Heavy Commercial Vehicles

Subject	H476MCA 9S Eaton Manual Transmission Shifter Replacement
Variant	2016 MY (H476 MCA)
Abstract	This TSB released to explain details for Shifter Replacement in vehicles with 9S EATON Manual transmissions

Photo 1

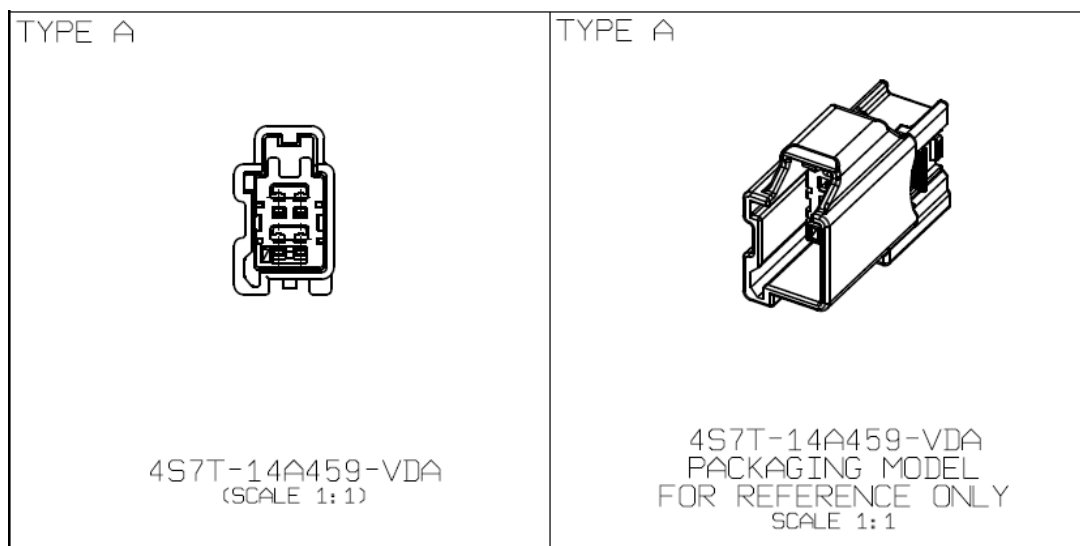
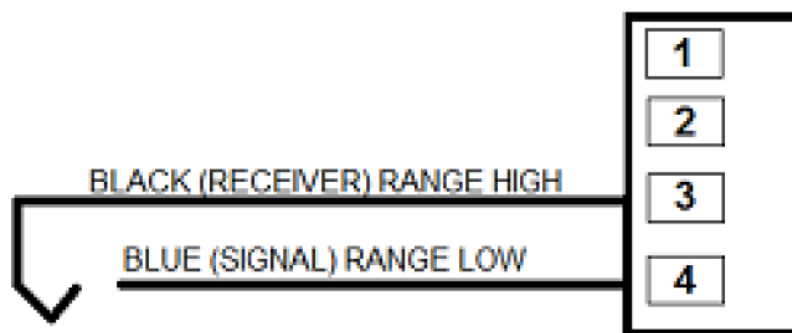
1. The shift knob wiring connector must be detached from the current wiring on vehicle. Use the connectors and terminal which included in the kit **(JC46 14B475 EVB)** instead of current one. **(Photo-1)**
2. Use the terminals on new connector **Pin Number 3 and Pin Number 4**
3. After installation of new shifter **(JC46-7213-BA)**, use the new connector with the new part.
